Upgrade Procedure

AS7500 Tru Count Valve Box Upgrade

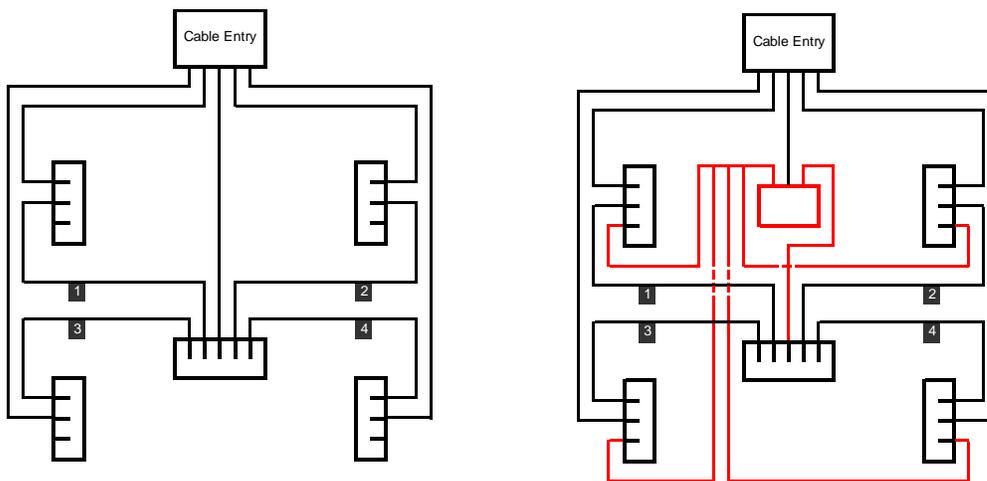
- IV. Final Wiring
 - a. In the standard valve boxes (on left below) the five wires from the cable entry split with the four wires going to each of four walnut connectors. Each switch (1-4) has one wire connected to one of 3 wire connectors and the other

connected to the same 5 wire common block. A ground wire is connected from the cable entry to the common block.

- b. To modify the valve box (in red on right below) to work with the AS7500, the wire harness needs to be added. The red ground wire coming from the cable entry to the 5 wire walnut connector is removed and added to the new 3 wire walnut connector. One wire from the new connector is connected to the 5 wire walnut. The remaining four leads are connected to the four spare slots in the 3 wire walnut connectors.
- c. After installation of the boxes, a final test of the AS7500 should be undertaken by connecting and running a self test of the appropriate number of sections.
